Powerhouse Fast-track Application

Otago Regional Council Pre-Application Information Response

Date: 11 December 2025

Pre-Application Information Response

Figure 4.8: Different levels of analysis recommended for plan development/review/change, land-use and subdivision consent and building consent. See Section 6 and Table 4.2 for more detailed information.

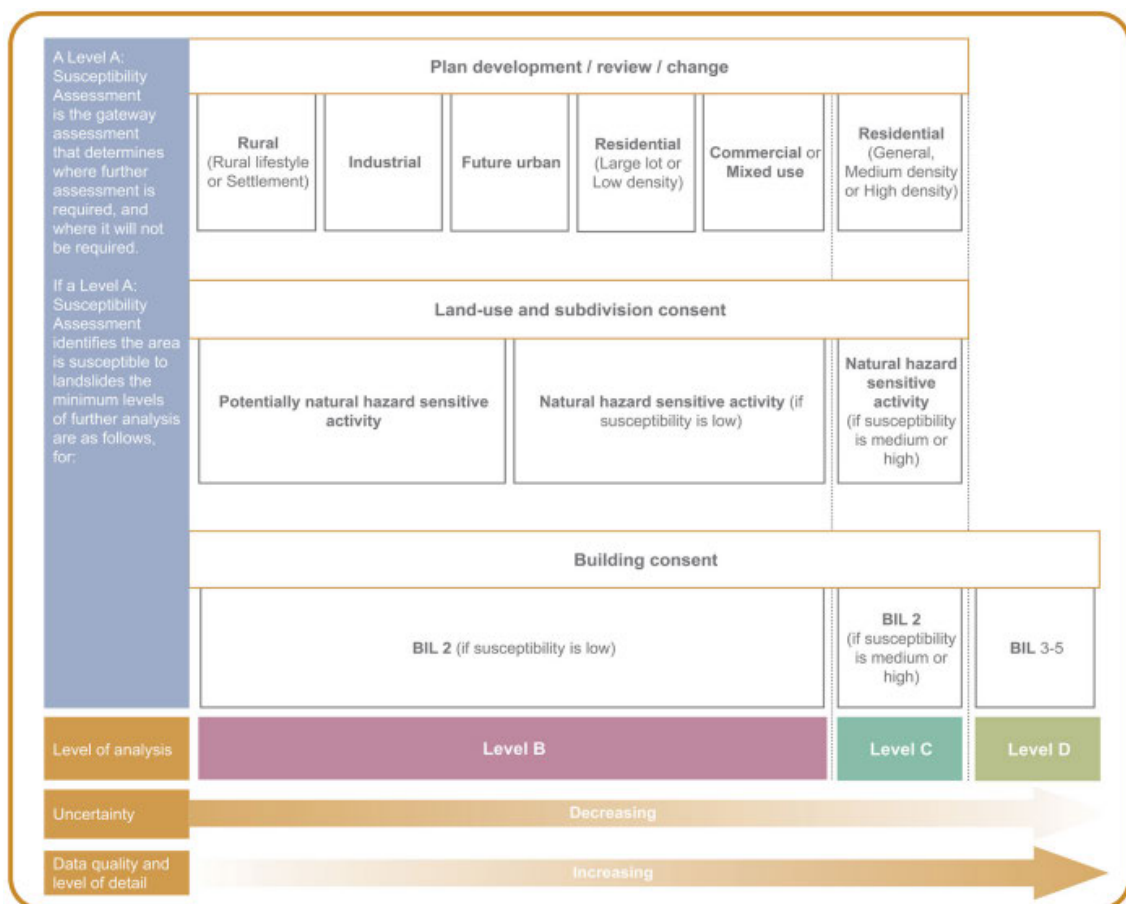
The current assessment by Geoconsulting Ltd is completed only at about a ‘Level A’ level of detail (e.g. a basic mapping of landslides and land potentially susceptible to landslide, but no information on landslide frequency or runout area etc).

This guidance recommends that investigations of at least a ‘Level B’ detail are undertaken for plan change/landuse or subdivision consenting (e.g. see Figure 4.8, copied below).
